RE: SES Solar One Project
Applicant's Responses to the CEC Memo Regarding Transmission Line Upgrades

SES Solar One
Response to CEC Memorandum
Docketed 12/8/2009
08-AFC-13

TECHNICAL AREA: TRANSMISSION LINE UPGRADES

9

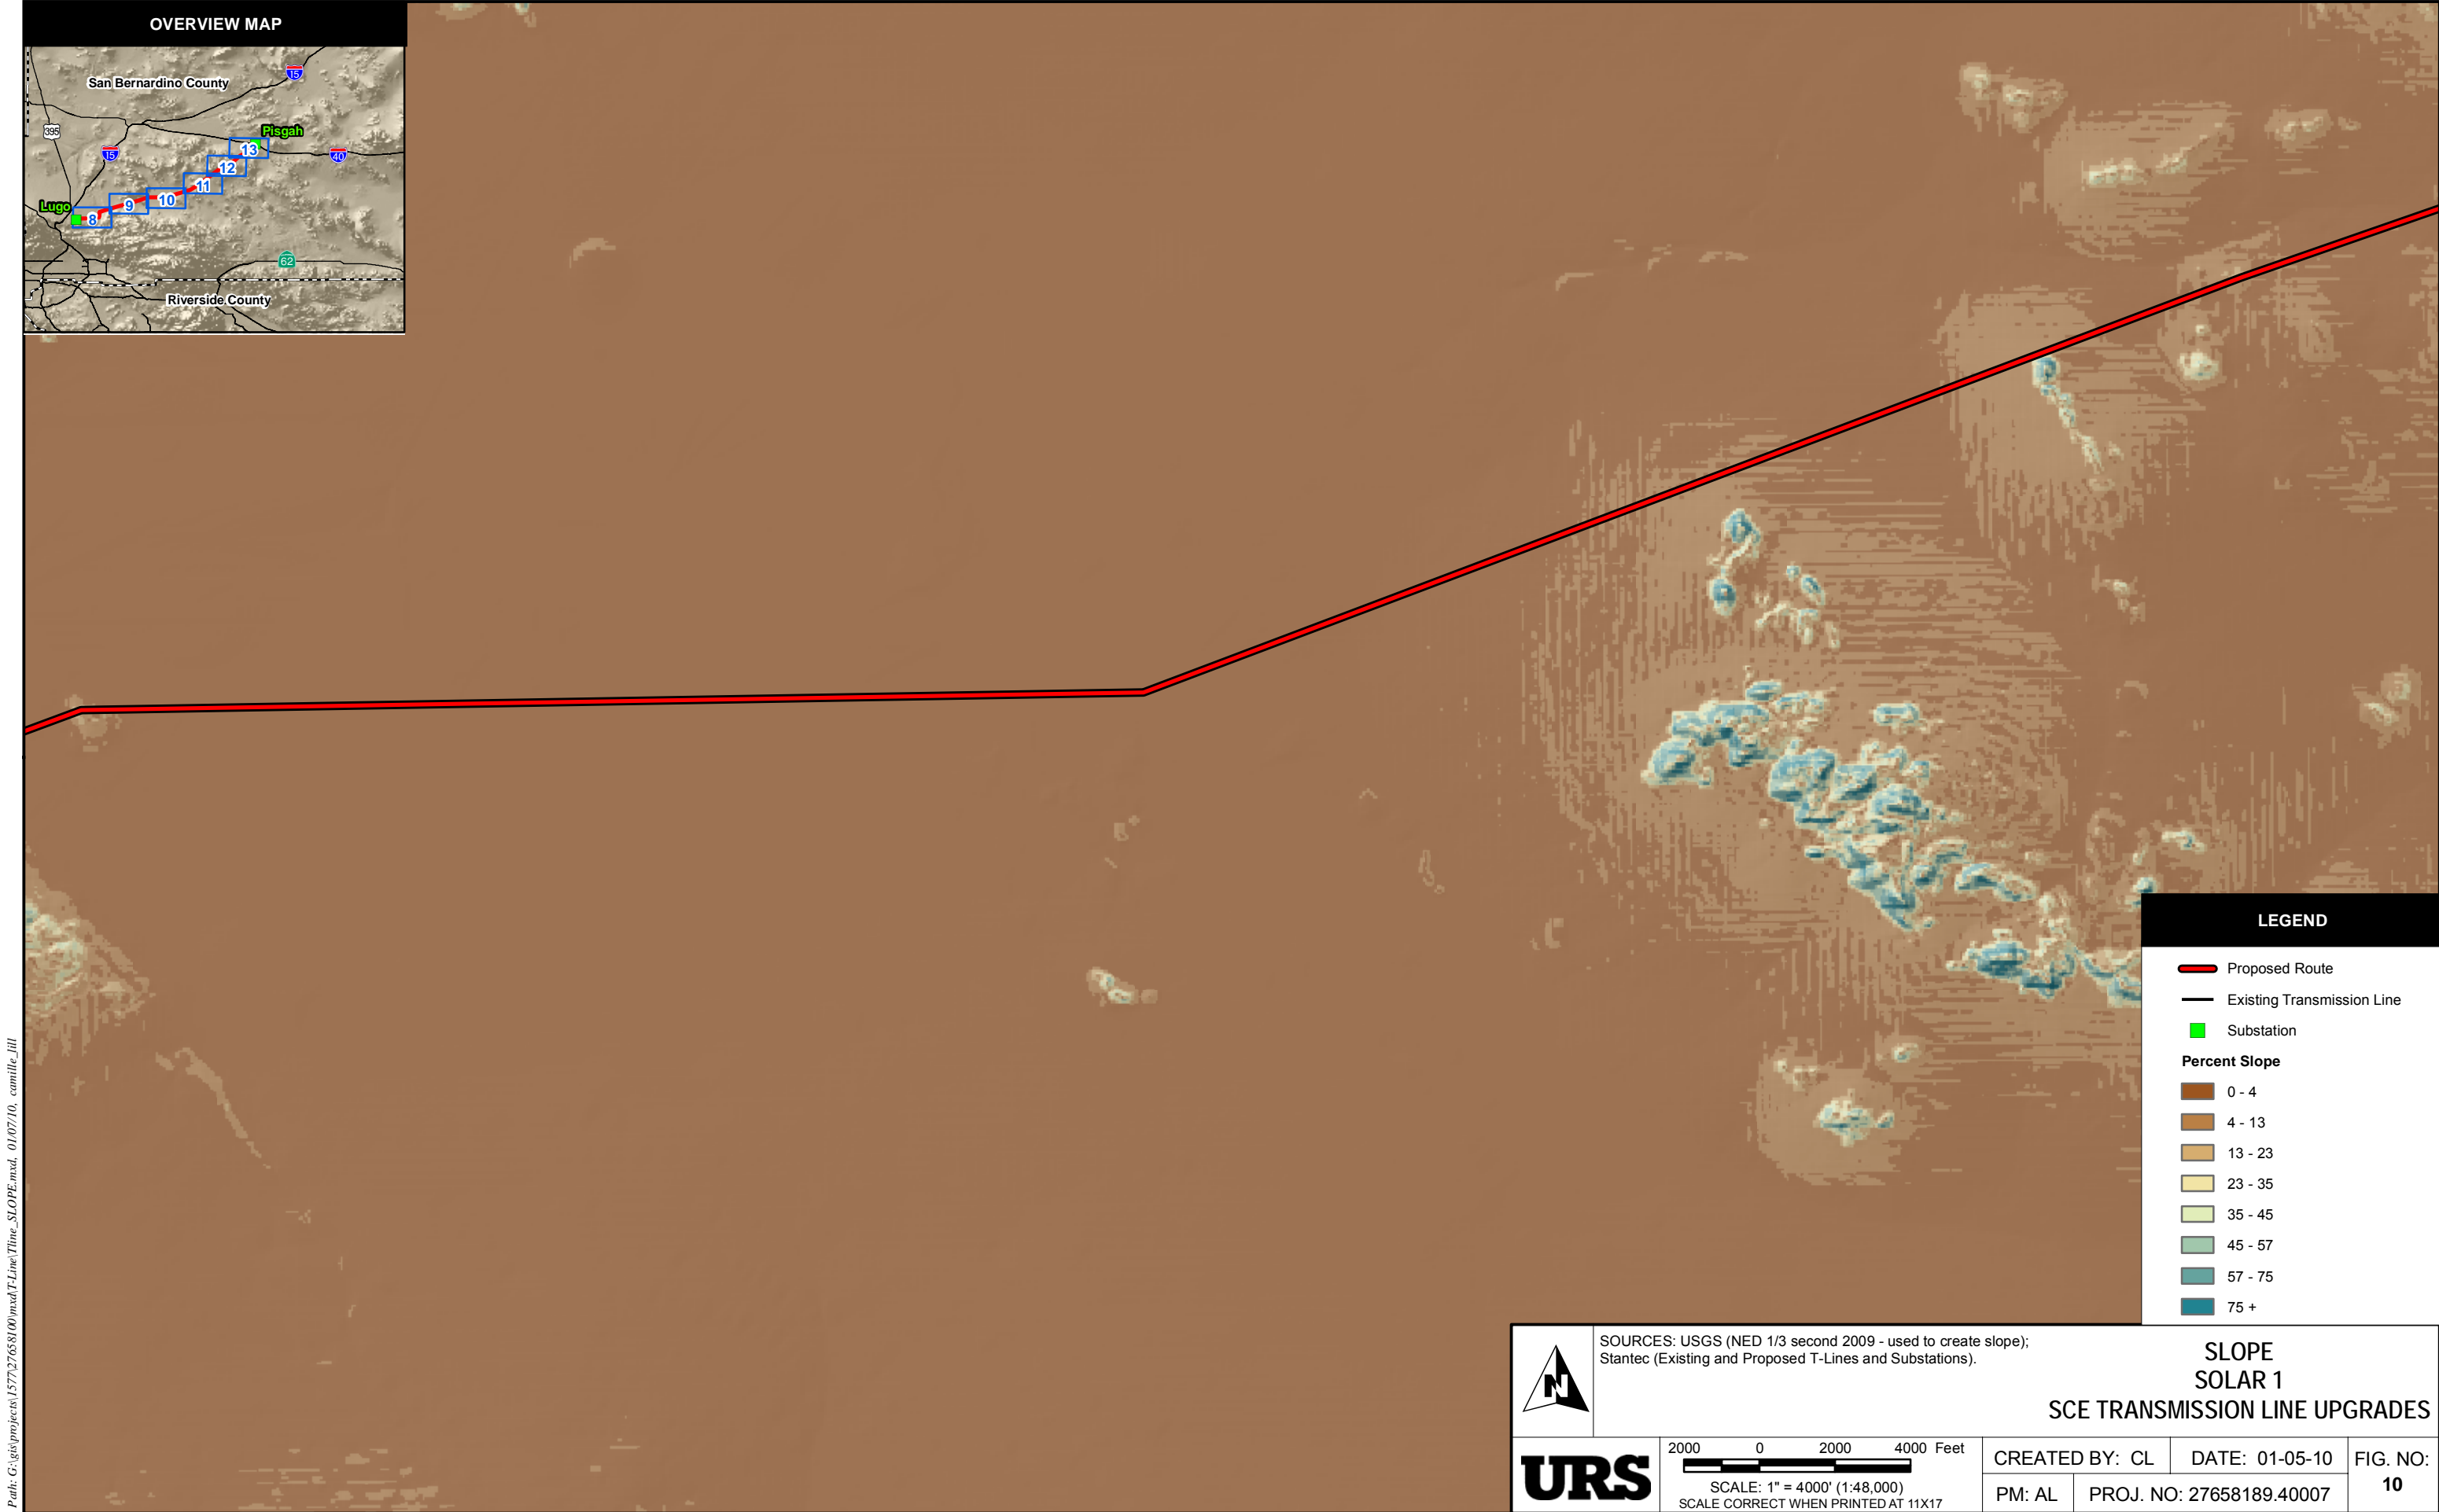
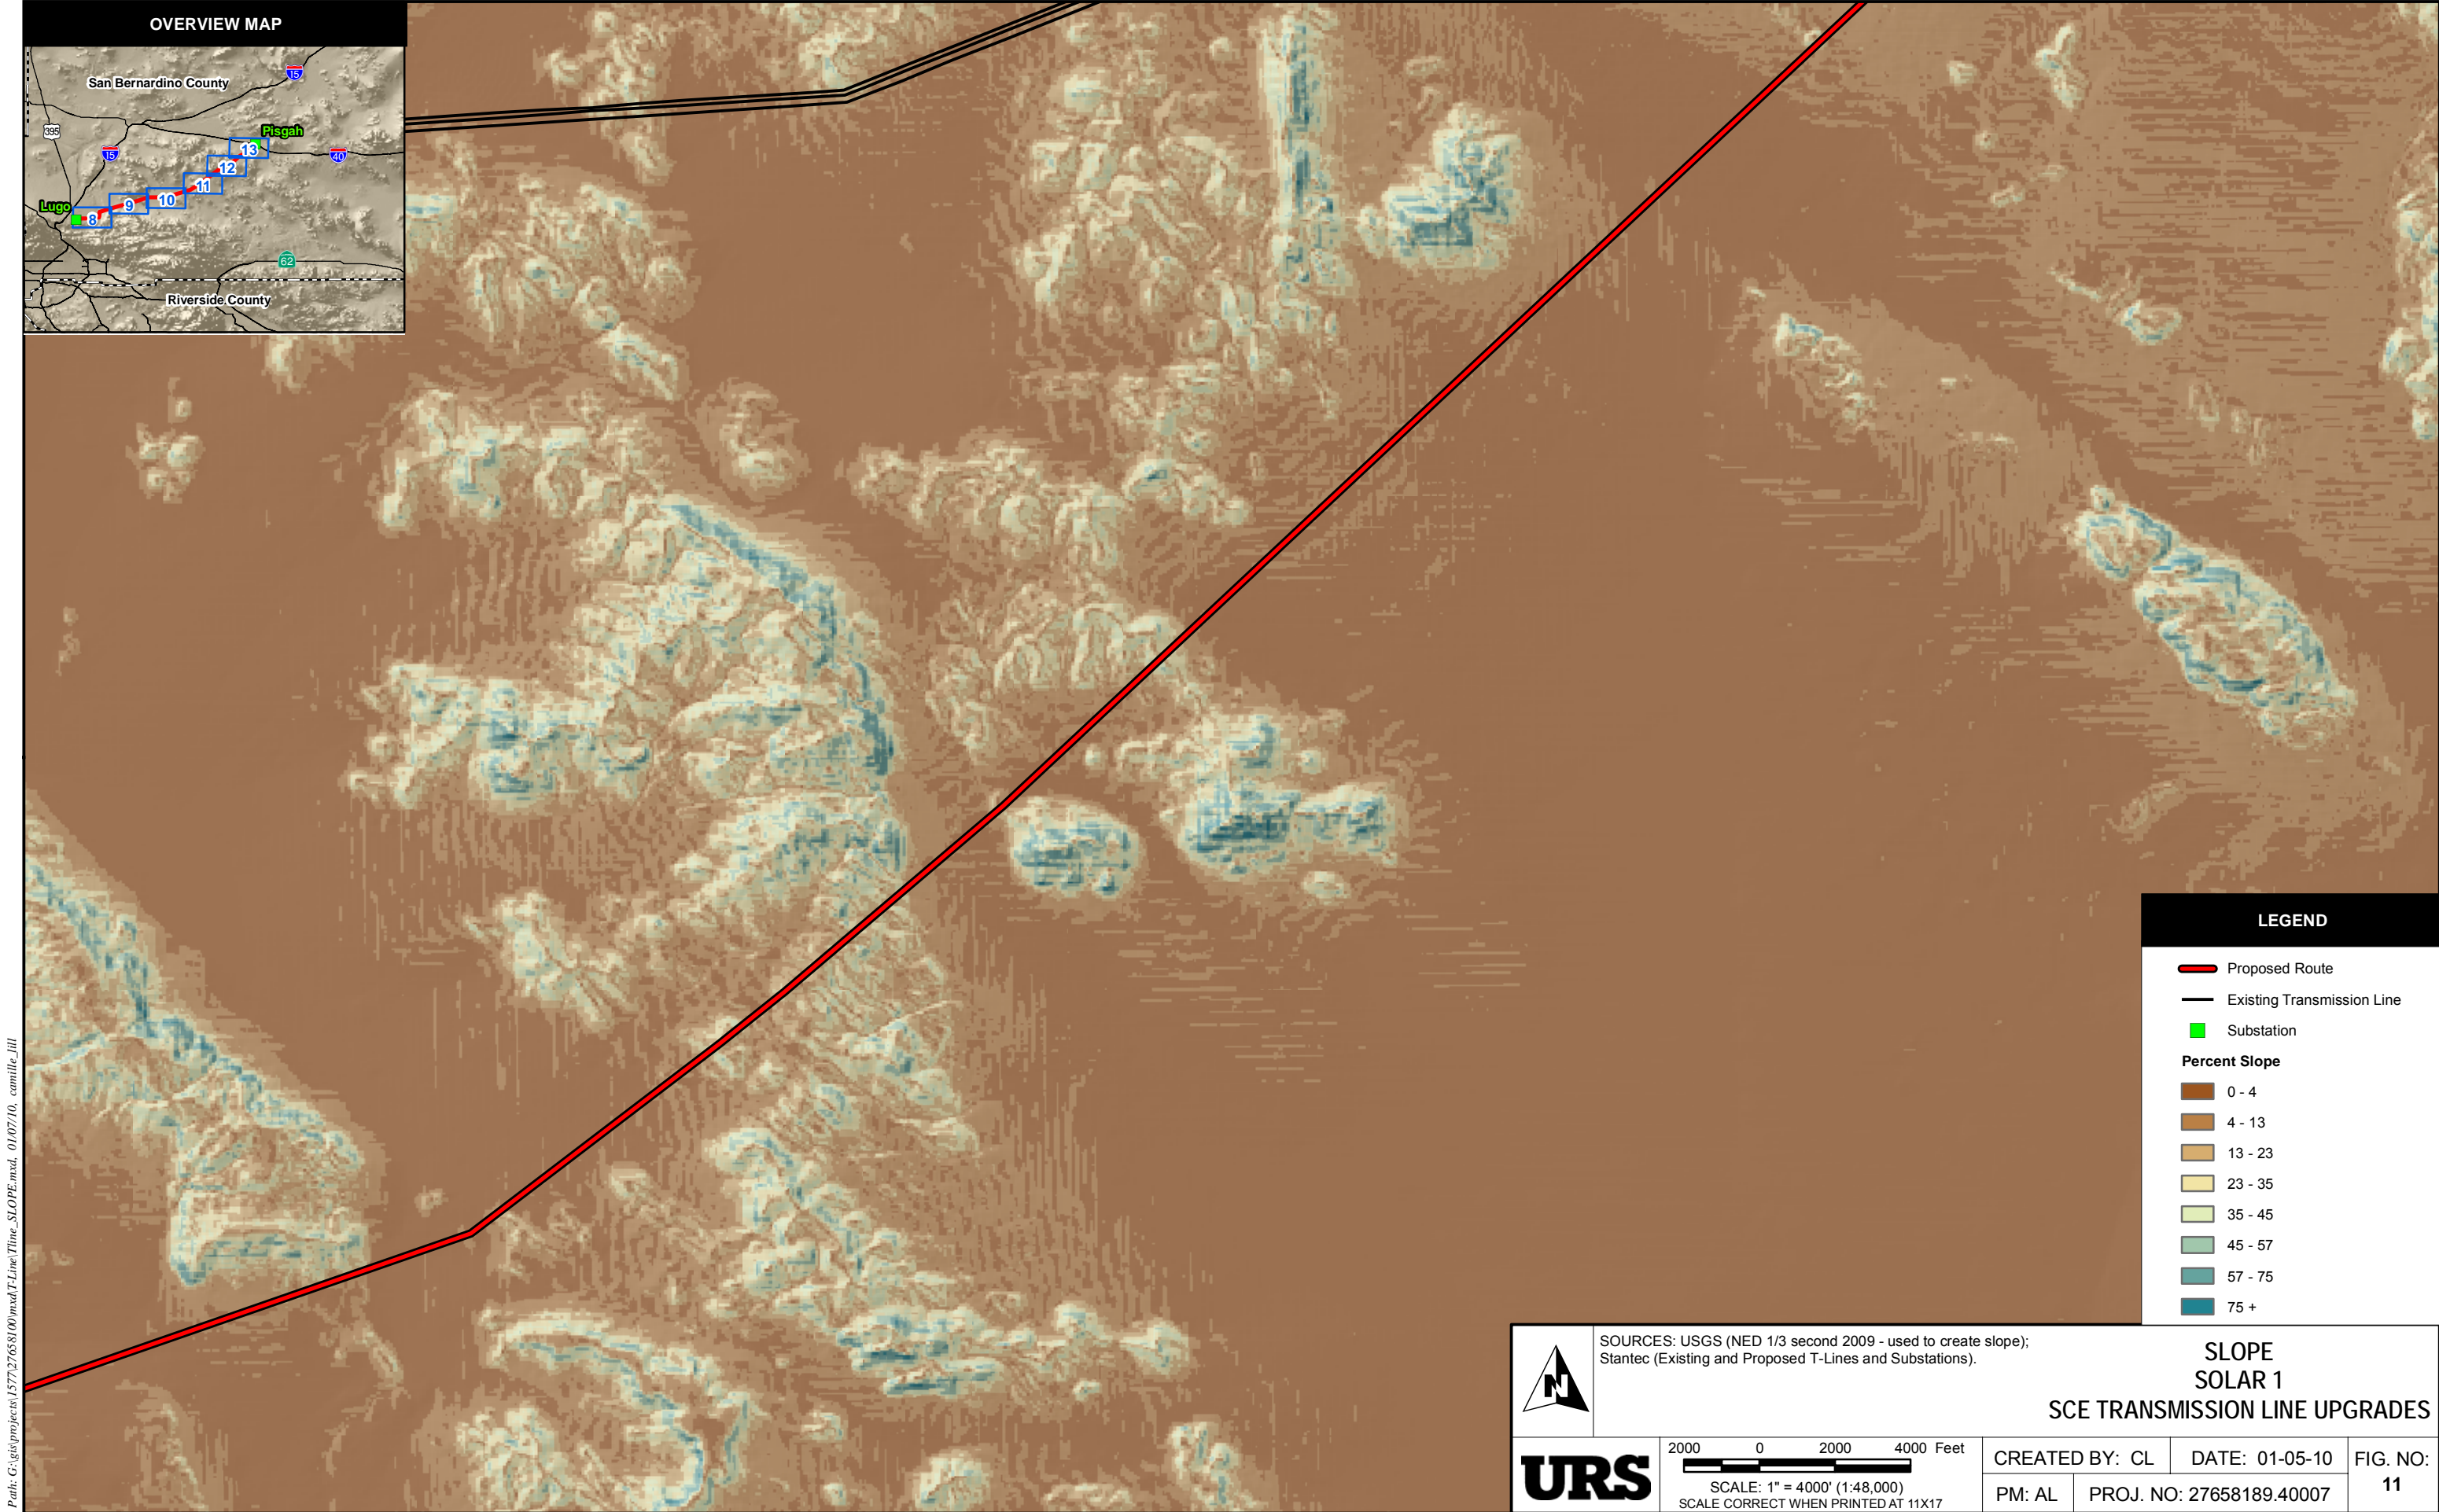
Item 10: Provide the slope gradients traversed by the alignments of transmission line upgrades and roads.

Response: Slope gradients for the proposed alignments (as shown in the AFC) and roads are depicted in attachment TRANS-5.
